MAP OF HELL'S KITCHEN NEIGHBORHOOD

# Conceptual Phase

# Preliminary Design

# Perimeter Site Fence

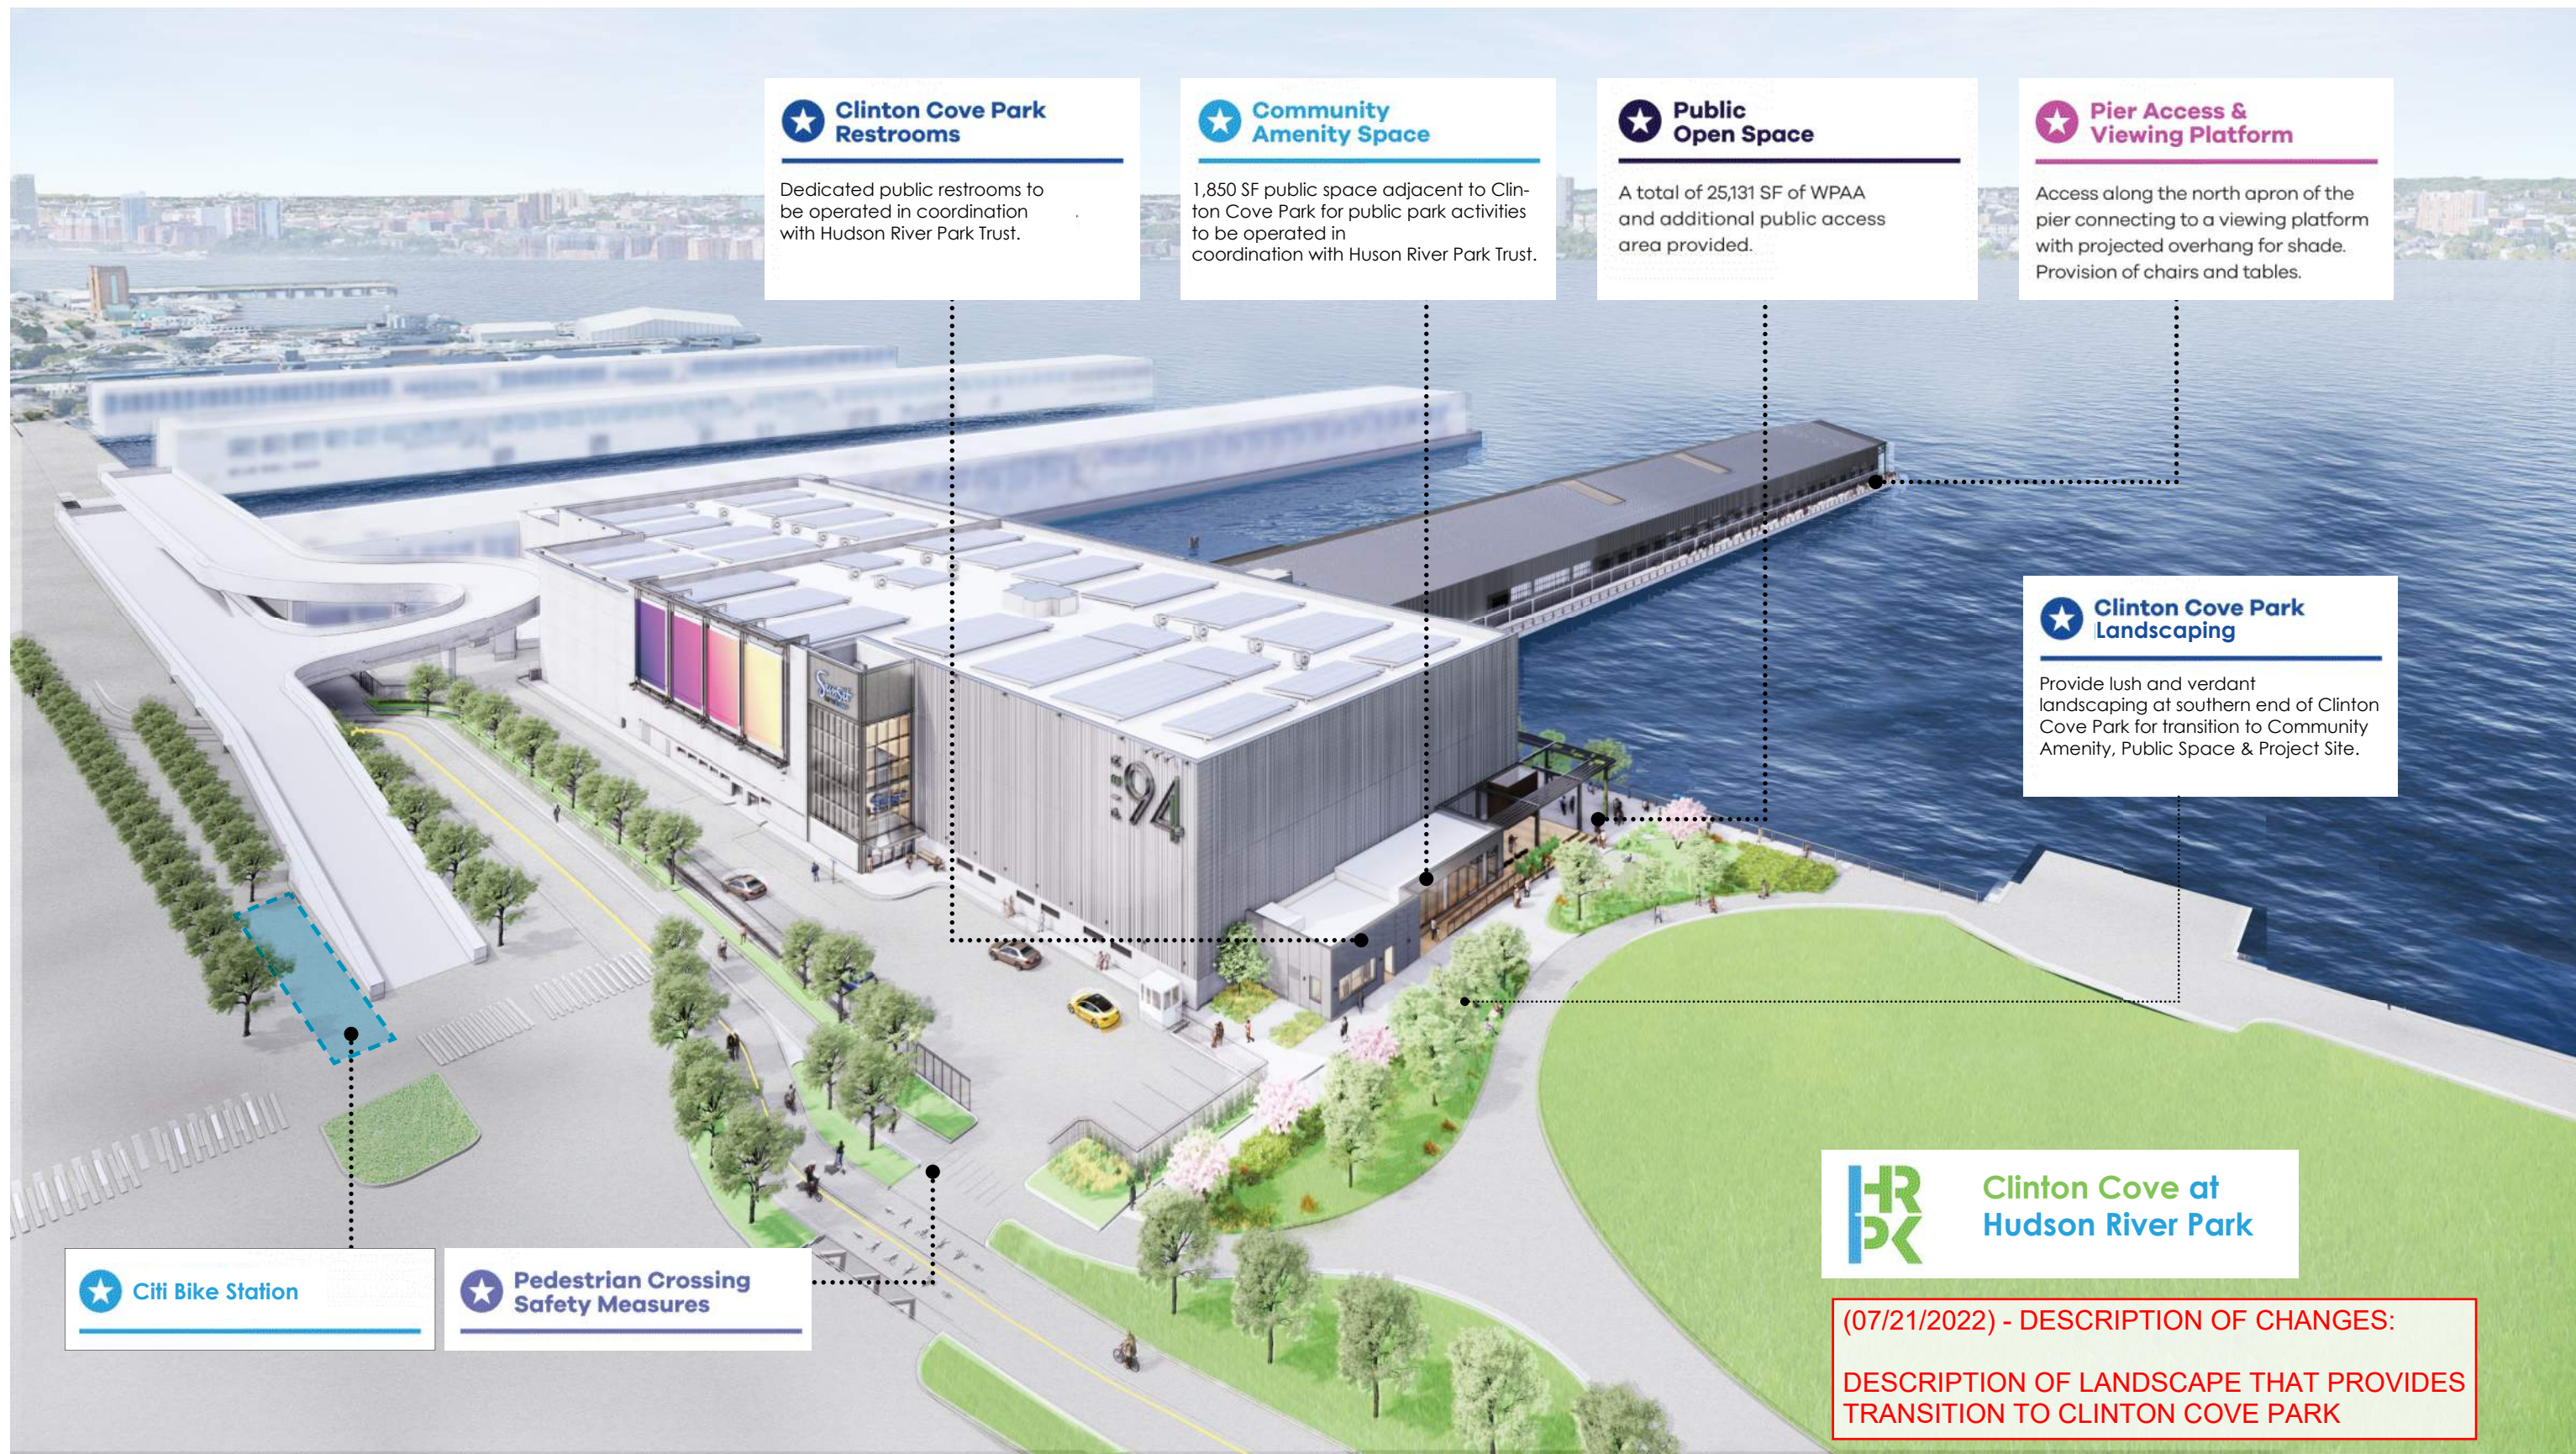
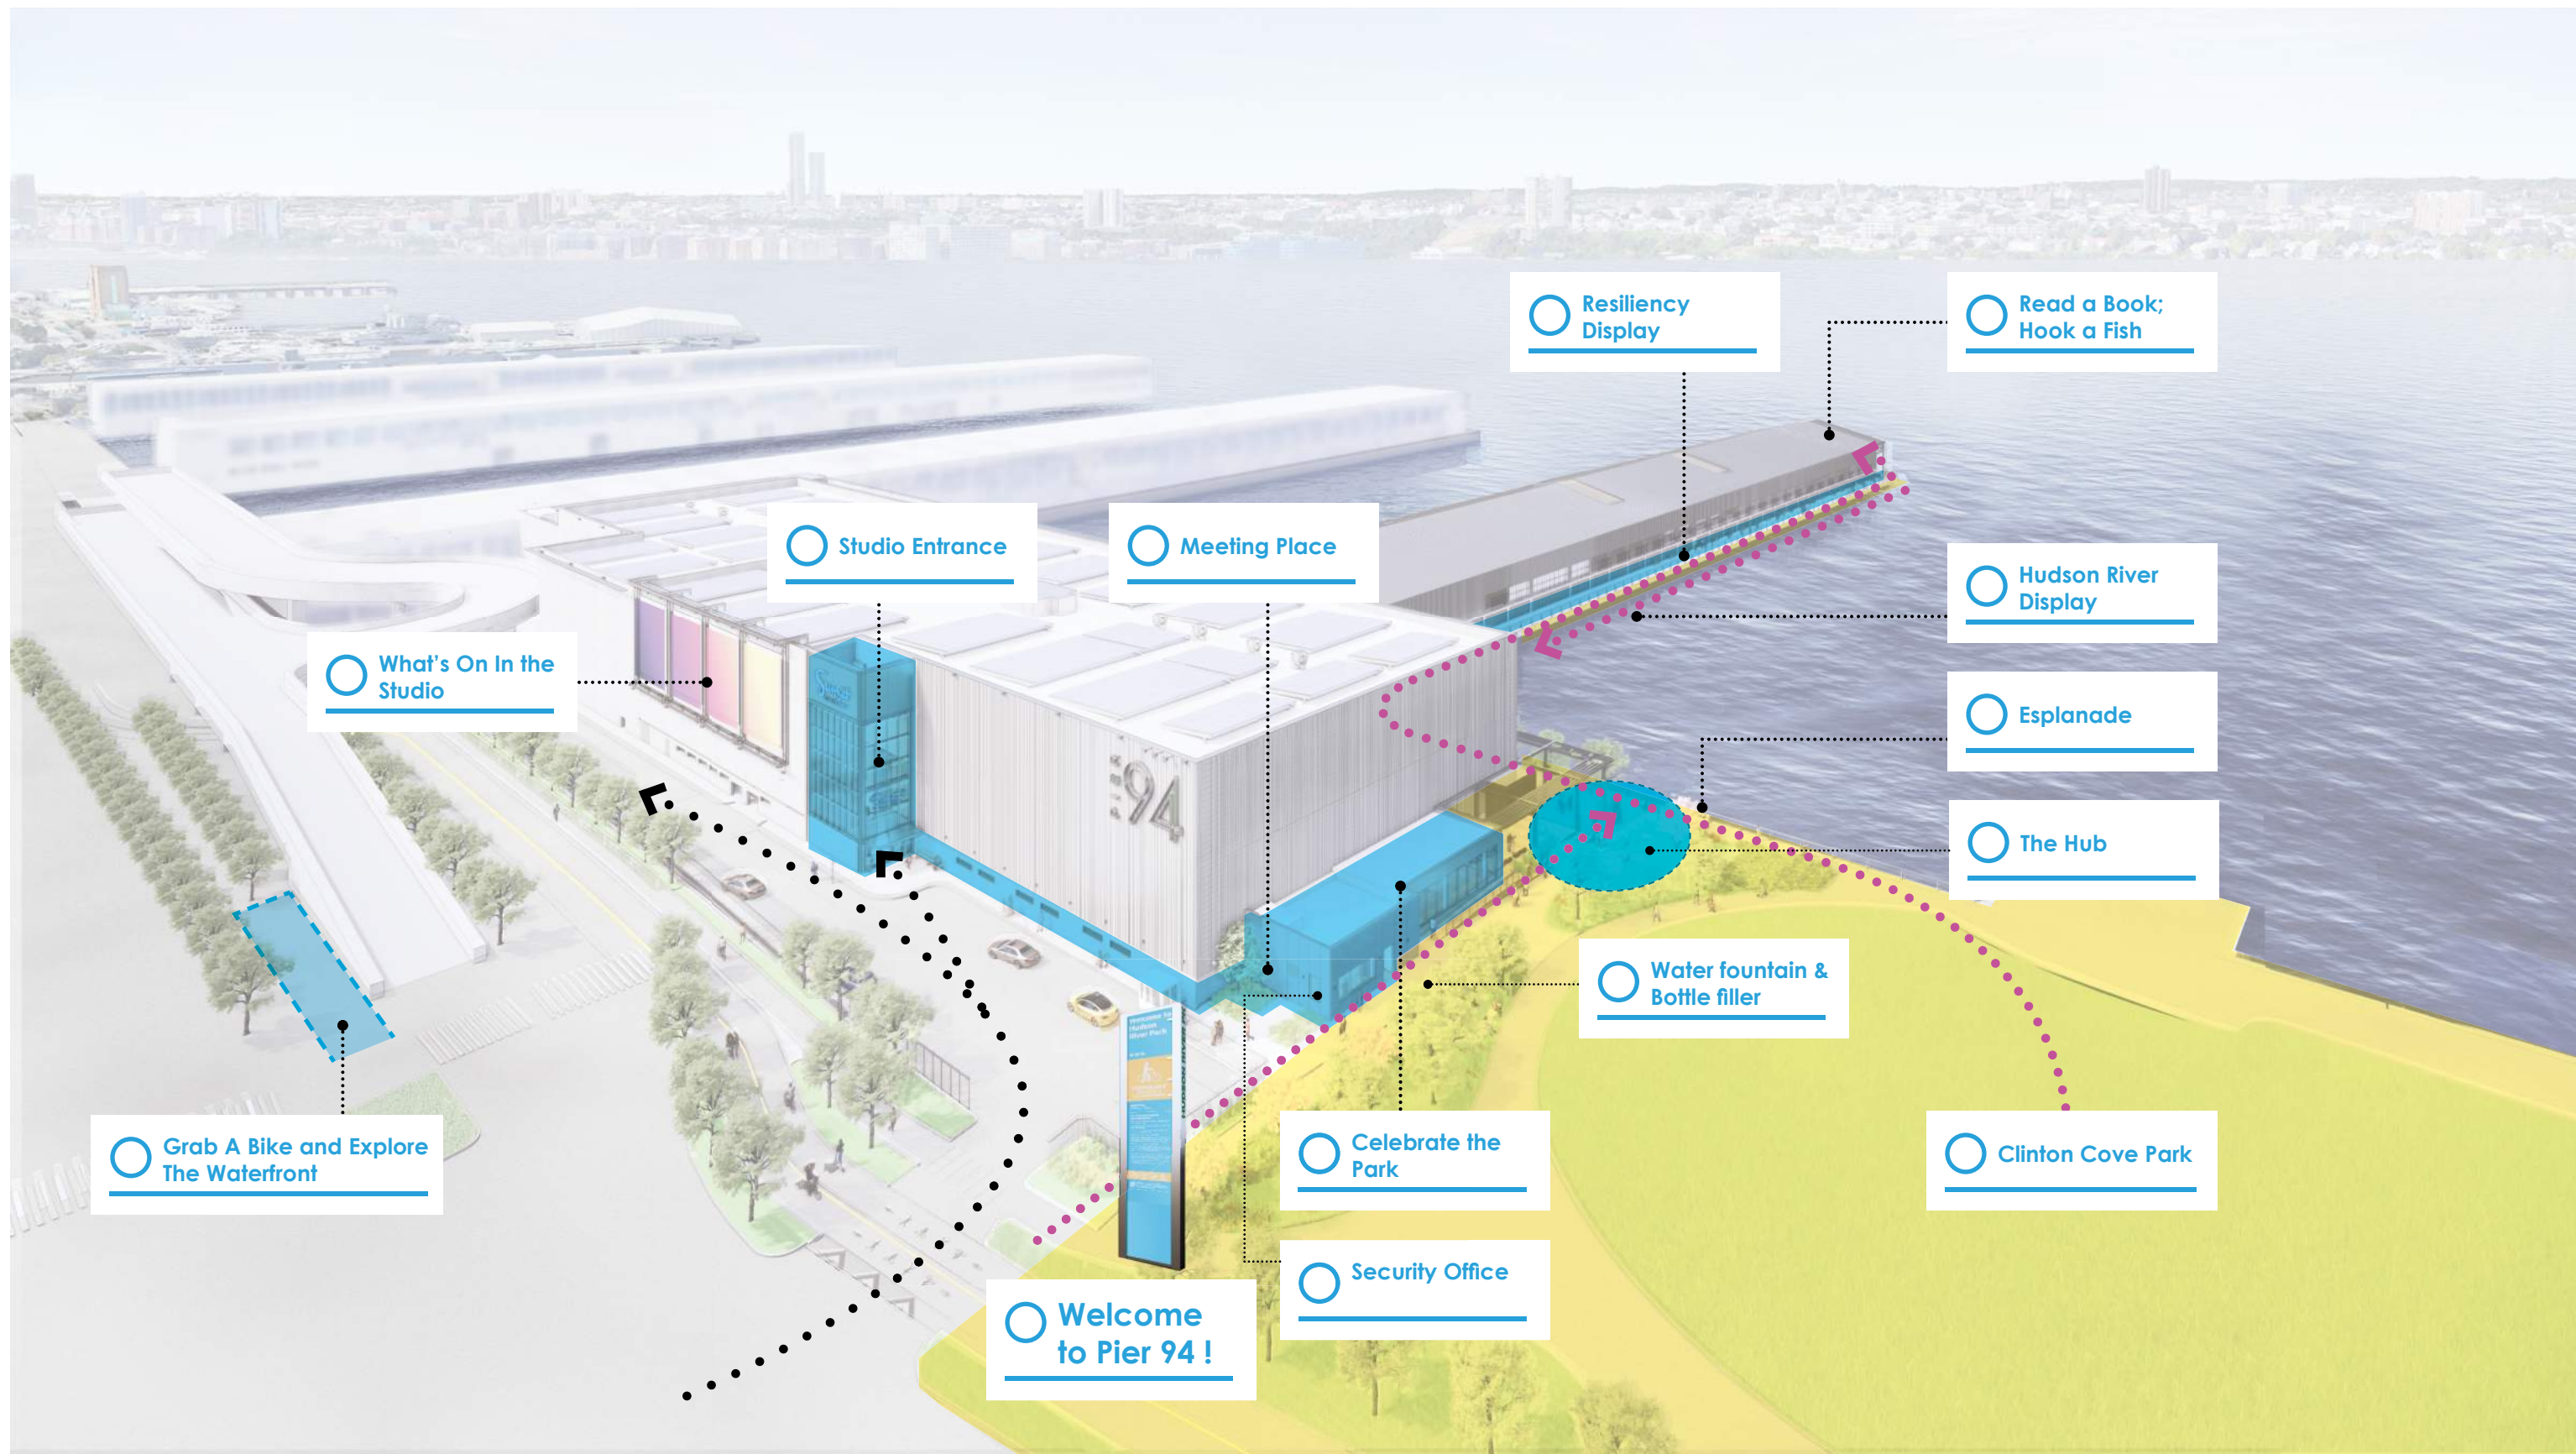
IN RESPONSE TO COMMISSIONERS COMMENTS,  
THE SITE FENCE HAS BEEN LOWERED TO 6'-6"  
FOR THE ENTIRE LENGTH

IN RESPONSE TO COMMISSIONERS COMMENTS,  
THE SITE FENCE HAS BEEN LOWERED TO 6'-6"  
FOR THE ENTIRE LENGTH

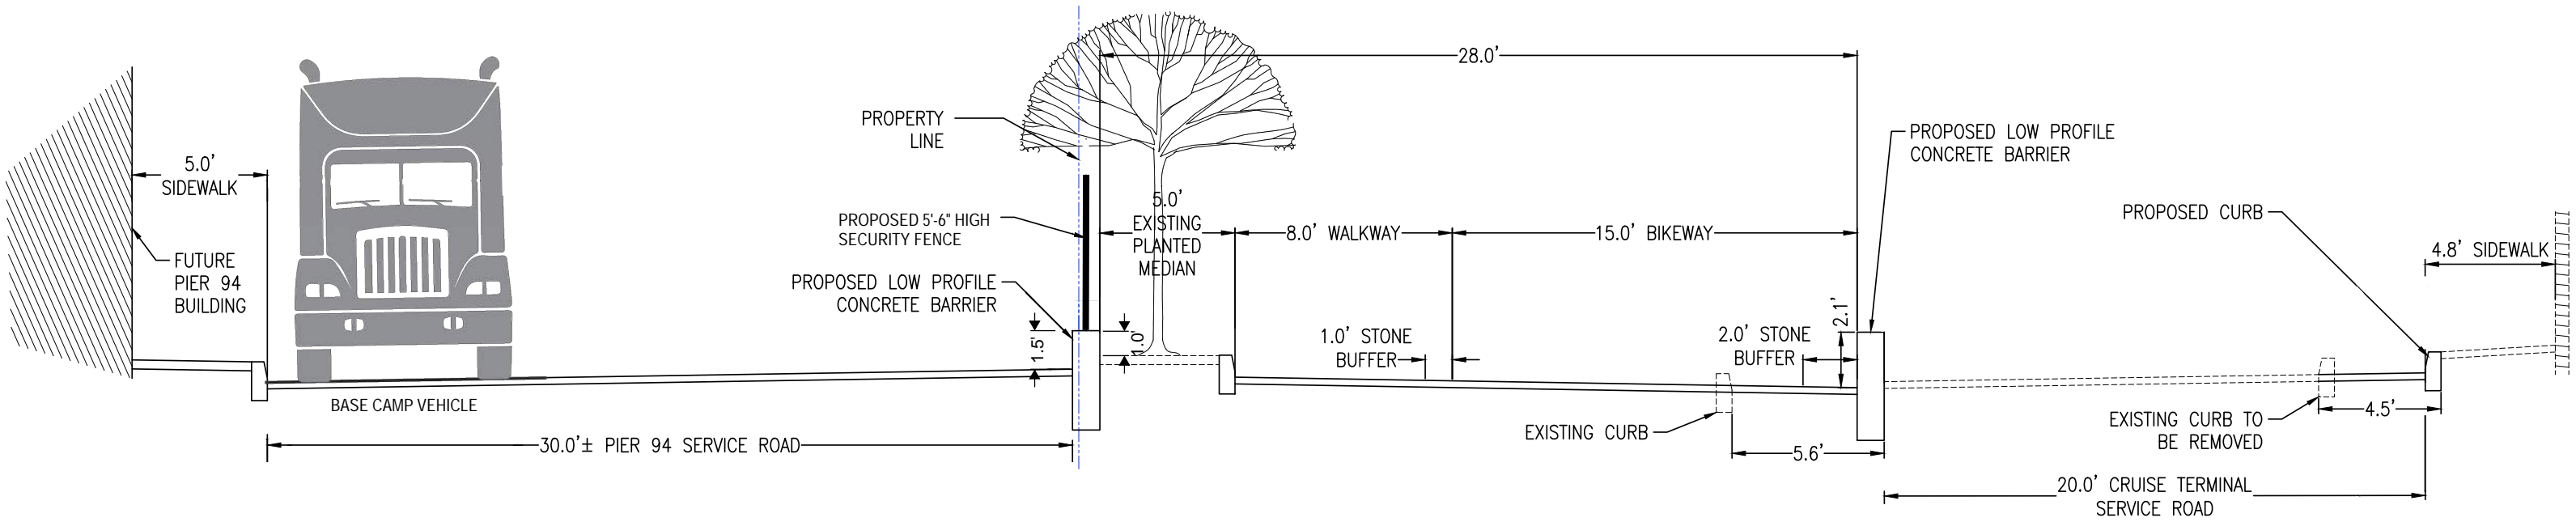
IN RESPONSE TO THE COMMISSIONERS  
COMMENTS, THE SITE FENCE HAS BEEN  
REDUCED TO A UNIFORM HEIGHT OF 6'-6"  
FROM GRADE

07/21/2022 DESCRIPTION OF CHANGES:

1. LOWER FENCE HEIGHT INDICATED.
